## Service Bulletin

No. : MZ08-013

**Model:** SR8002

**Subject:** Circuit Modification Information: Power Supply Circuit (3.3V) for HD Radio Module

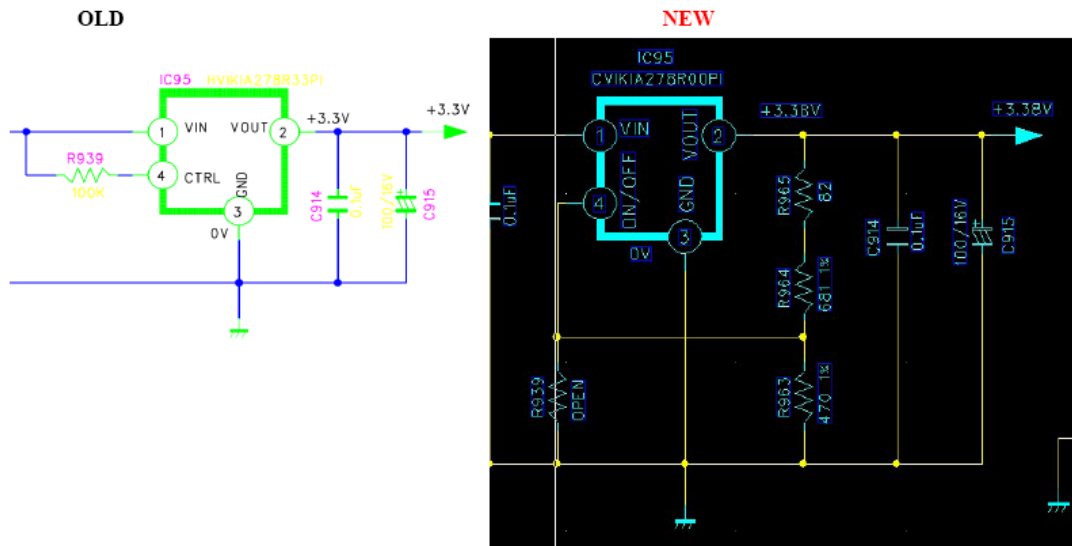
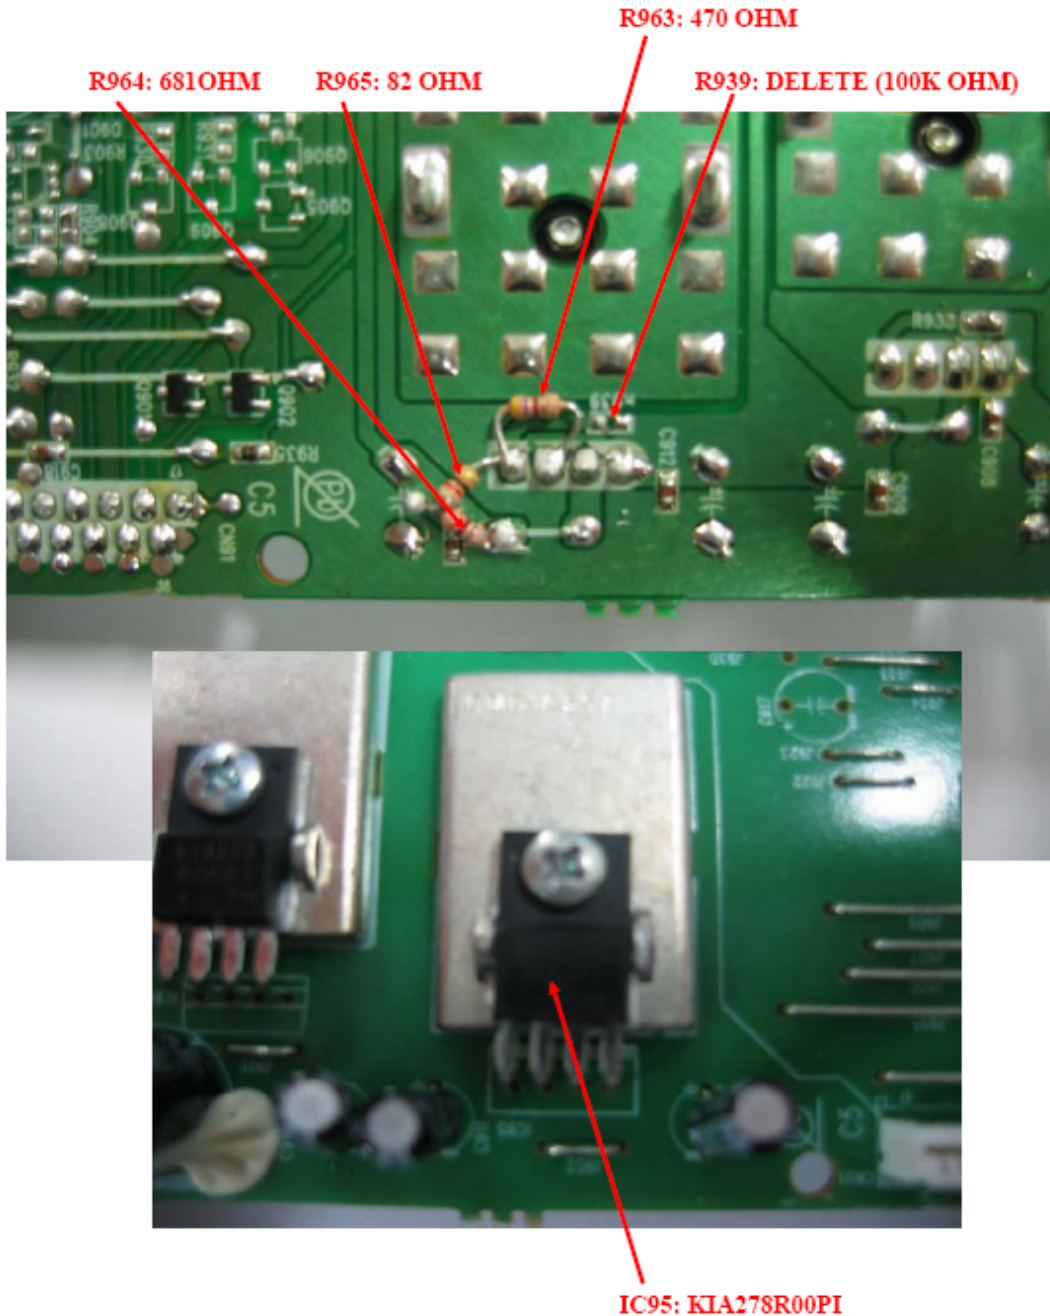
**Symptom:** Due to a low marginal voltage output capacity, the power supply circuit for the HD Radio Module was being manufactured with a selected 3.3V DC regulator IC. The circuit layout has been reconfigured to improve productivity.

**Solution:** Please see the following pages for a comparison of the old and new circuits.

DELETE ADD	P.W.B. NAME	POS. NO	PART NO. (MZ)	PART NAME	DESCRIPTION
DELETE	HD R	IC95	90M-HC300740R	IC	KIA278R33PI Factory code no. HVIKIA278R33PI
ADD	HD R	IC95	90M-HC301010R	IC	KIA278R00PI Factory code no. CVIKIA278R00PI
ADD	HD R	R963	90M-GD000380R	RES.	470 OHM 1/6W +- 1 % Factory code no. CRD20TF4700T
ADD	HD R	R964	90M-GD000390R	RES	681 OHM 1/6W +- 1 % Factory code no. CRD20TF6810T
ADD	HD R	R965	00MGD05820160	IC	82 OHM 1/6W +- 1 % Factory code no. CRD20TJ820T
DELETE	HD R	R939	00MNN05104610	CHIP RES.	100K OHM 1/10WJ Factory code no. CRJ10DJ104T

MZ020803001681 ~ manufactured with the new circuit layout.
